CHANGE OF VARIANT CODING FOR INDICATOR TYPE INFORMATION TYPE BULLETIN

AFFECTED MODEL: 2025 390 ADVENTURE X

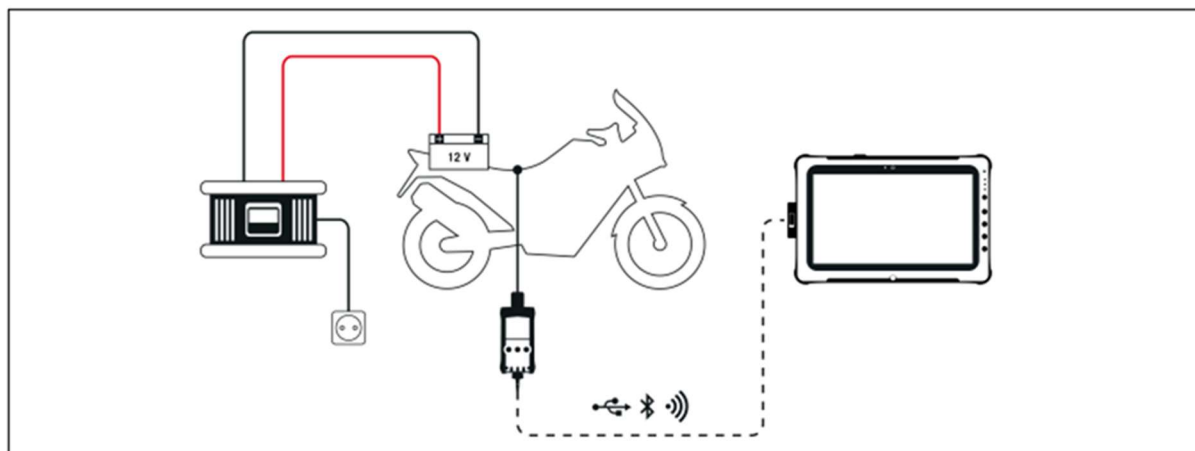
During quality checks, it was noticed that in some cases the indicators were incorrectly coded in the combination instrument.
